# UNITED STATES PATENT AND TRADEMARK OFFICE

APPLICATION NO.	FILING DATE	FIRST NAMED INVENTOR	ATTORNEY DOCKET NO.	CONFIRMATION NO.
10/524,763	04/26/2005	Matthias Muller	NY-DNAG-300-US	3415
24972	7590	05/03/2006	EXAMINER	
FULBRIGHT & JAWORSKI, LLP 666 FIFTH AVE NEW YORK, NY 10103-3198			ADDISU, SARA	
			ART UNIT	PAPER NUMBER
			3722	
DATE MAILED: 05/03/2006

<b>Office Action Summary</b>	<b>Application No.</b> 10/524,763	<b>Applicant(s)</b> MULLER ET AL.	
	<b>Examiner</b> Sara Addisu	<b>Art Unit</b> 3722

**FIG. 2**

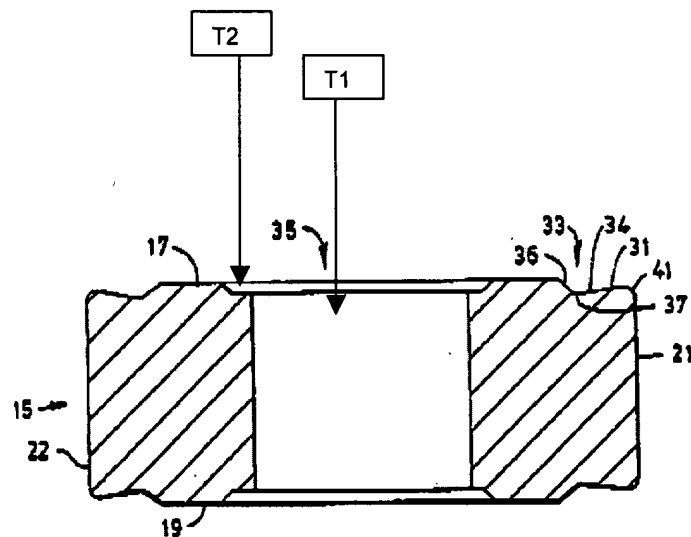
Regarding claim 11, KATBI ET AL. teaches a cutting plate (15) comprising an upper side (17), a first clamping trough (T1: through hole part of opening 35), a cutting edge, a second clamping portion (T2: see figure below) arranged coaxially with respect to the first clamping trough ('061, figure 2). The first clamping trough (T1) is deeper than the second clamping portion (T2). KATBI ET AL. also teaches in figure 2, both troughs (T1, T2) being arranged such that they are deeper than upper surface (17). Regarding claim 12, KATBI ET AL. teaches in figure 1, both clamping troughs being round.

Regarding claims 17, 23 and 24, as shown in the figure below, T2 forms an annular surface that is parallel to the upper side (17). Regarding claims 29, 30, 35, 36, 41, 42, 47, 48, 53, 54, 59, 60 and 65, KATBI ET AL. teaches an indexable ceramic insert.

KATBI ET AL. teaches a cutting plate (15) comprising an upper side (17), a first and second clamping trough (T1, T2), as set forth in the above rejection. Furthermore, regarding claims 19-22 and 25-28, as shown in the figure above, T2 forms an annular surface that is parallel to the upper side (17). Regarding claims 31-34, 37-40, 43-46, 49-52, 55-58, 61-64 KATBI ET AL. teaches an indexable ceramic insert. Regarding claim
